<b>Title - Sujet</b> CCGS Cove Isle-Winter Refit	
<b>Solicitation No. - N° de l'invitation</b> F2599-195099/A	<b>Amendment No. - N° modif.</b> 001
<b>Client Reference No. - N° de référence du client</b> F2599-195099	<b>Date</b> 2019-12-12
<b>GETS Reference No. - N° de référence de SEAG</b> PW-\$\$\$MD-043-27526	
<b>File No. - N° de dossier</b> 043md.F2599-195099	<b>CCC No./N° CCC - FMS No./N° VME</b>
<b>Solicitation Closes - L'invitation prend fin</b> <b>at - à 02:00 PM</b> <b>on - le 2020-01-06</b>	<b>Time Zone</b> <b>Fuseau horaire</b> Eastern Standard Time EST
<b>F.O.B. - F.A.B.</b> <b>Plant-Usine:</b> <input type="checkbox"/> <b>Destination:</b> <input type="checkbox"/> <b>Other-Autre:</b> <input type="checkbox"/>	
<b>Address Enquiries to: - Adresser toutes questions à:</b> Pandini, Madeleine	<b>Buyer Id - Id de l'acheteur</b> 043md
<b>Telephone No. - N° de téléphone</b> (819) 420-1593 ( )	<b>FAX No. - N° de FAX</b> ( ) -

### **Solicitation Amendment # 1**

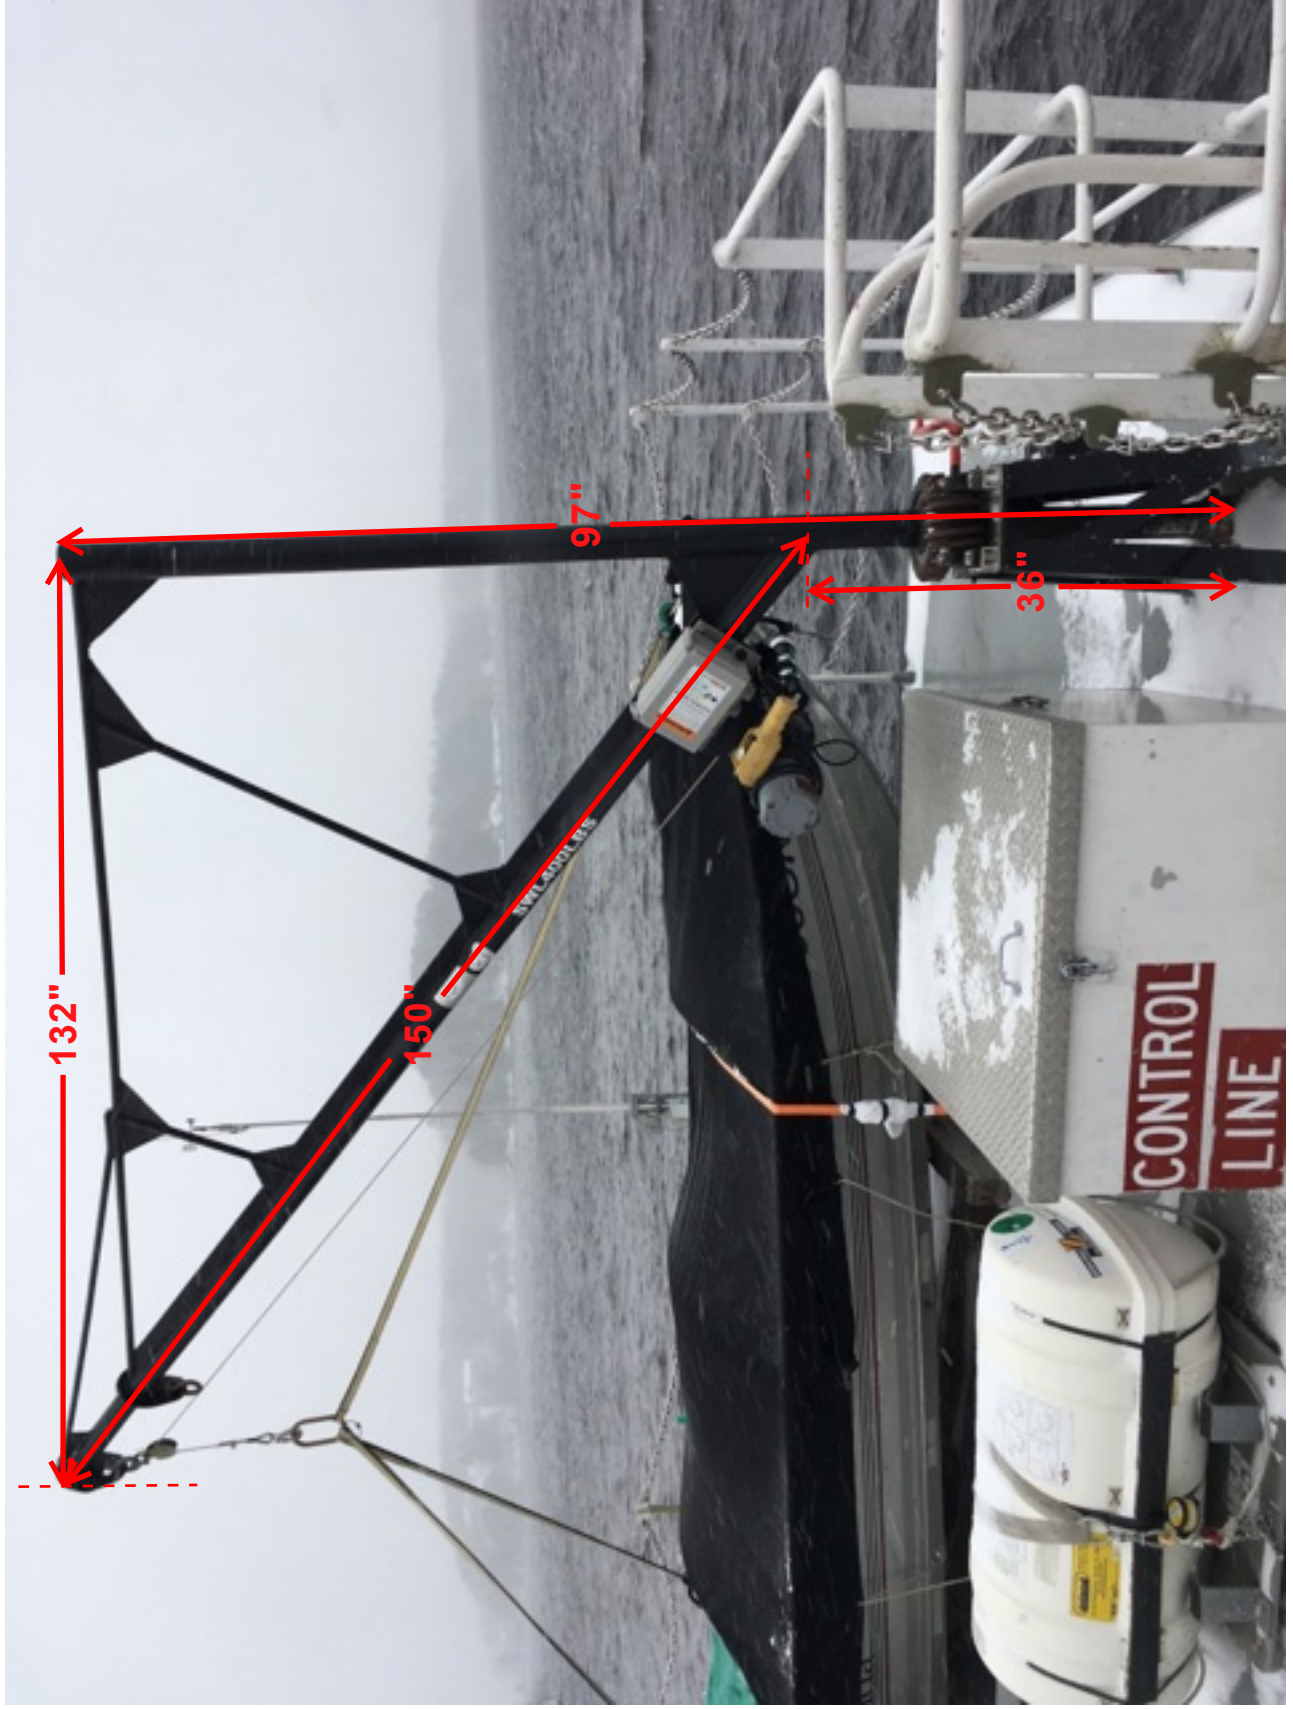
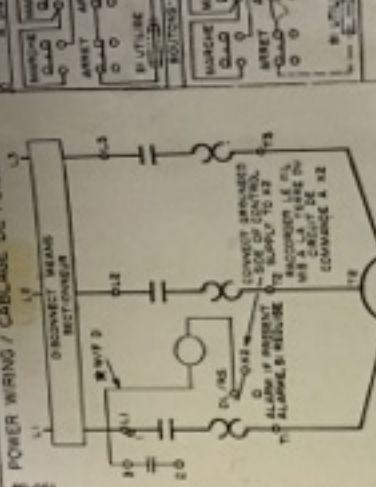
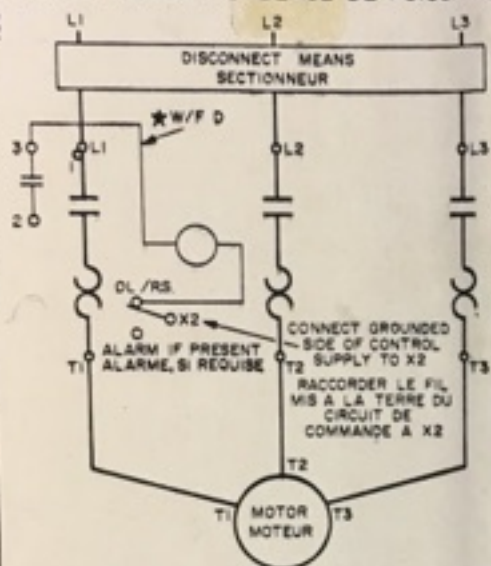
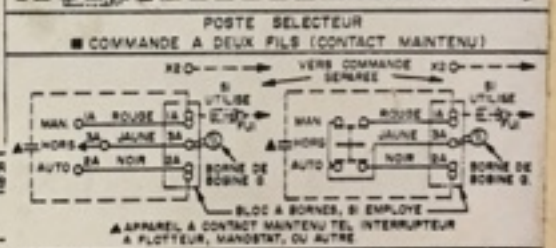
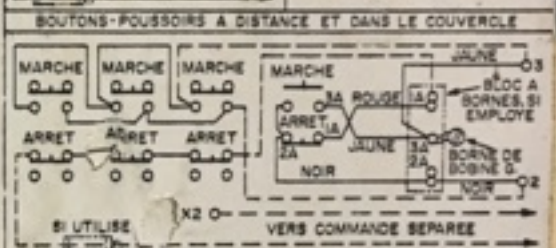
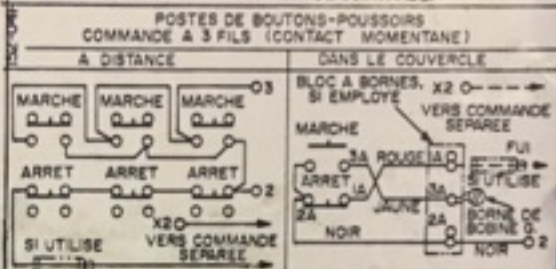
**Q5. In section 15.0 (Annex A, 15.1.C.1.5), there's a modification to be performed on the fire pump local control panel. Can you please provide electrical and mechanical drawings for this panel?**

**A5. Please refer to the attachment 'Fire pump controls.pdf' showing the diagram found in the panel door. The vendor shall provide a drawing for this panel, including the modification with the local/remote selector button.**
